<b>Title: Rotor Head Teeter Joint Setup</b>		
<b>AG-SIL-2024-02-EN</b>		<b>Released:</b>
<b>Applicability</b>		<b>1st March 2024</b>
<b>Aircraft type &amp; model:</b>	<b>Affected Serial number(s):</b>	
<b>All AutoGyro Models</b>	<b>all</b>	
The maintenance manual to be referenced is this stated or subsequent issue.		As per AutoGyro website
This form is the response from AutoGyro GmbH either against a problem found in the product in service requiring a containment or rectification action, or as service information for aircraft modification incorporation. For help, contact AutoGyro, email: <a href="mailto:airworthiness@auto-gyro.com">airworthiness@auto-gyro.com</a> .

**Reason and overview of the Service Information Letter**

Through recent development and vibration analysis tests it has been found that a slight modification in the setup of the teeter joint at the rotor head can result in a noticeable reduction in vibration. This SIL provides the information to embody this improvement.

Pic. 1

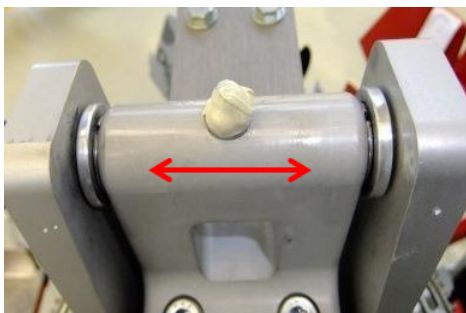
Step 10 of job card 62-11-00 4-4 should now read:

10. Install washer and castellated nut.

- i. Check lateral play of the teeter block in the teeter tower (Pic 1). If it is greater than 0.2mm contact AutoGyro for further support.
- ii. Tighten the castellated nut of the teeter bolt by hand until there is no lateral play discernable between teeter block and teeter tower, but at least one shim is able to be rotated (Pic 2).
- iii. Check whether the split-pin hole aligns. If it does not, remove the nut and assemble a 0.2mm shim (item 42945) and re-fit the nut. Tighten to the same position. The split-pin hole should now align. **Nut torque should be approximately 1-2Nm.**
- iv. Teeter the rotor and ensure that the teeter block rotates on the teeter bolt and not the teeter bolt in the teeter tower (Pic 3).
- v. Fit a new split-pin. Use split-pins only once.
